## FIELD OBSERVATION REPORT

Child Nutrition Building (Food Service Building, 202276 -CA8)

Report No: 30

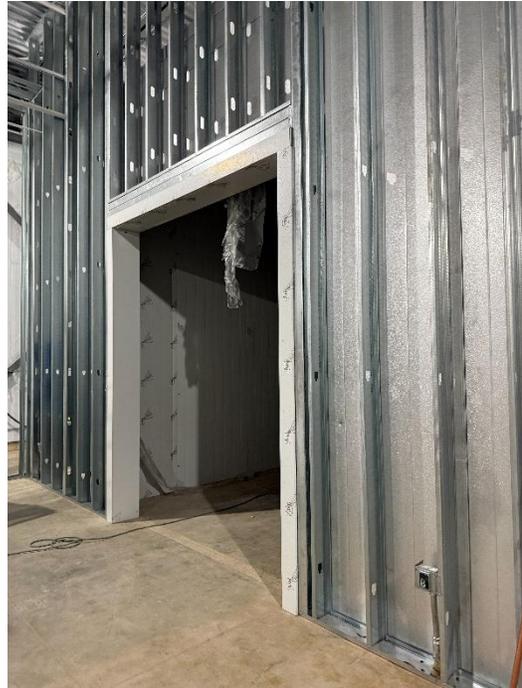
- q) On the south side of the side entrance, aluminum trim will be added and held in place with trim tape on the frame and sealant at the brick.

- r) On the north side of the side entrance, aluminum trim will be added and held in place with trim tape on the frame and sealant at the metal panel.

Once the trim is in place, the storefront will be the same width as the panels above.

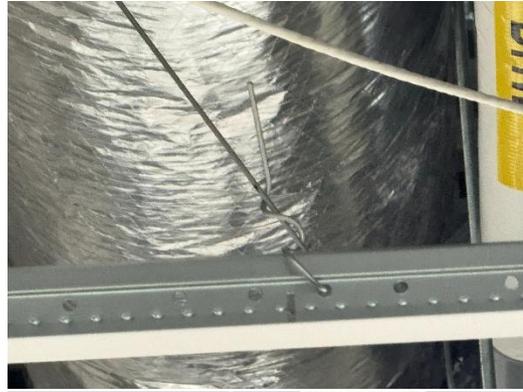
- v) During the ceiling inspection, we found that seismic clips were not consistently installed. These need to keep the grids from moving on two sides and movable on the opposite sides. They also need to be installed per the ceiling manufacturer's installation instructions.
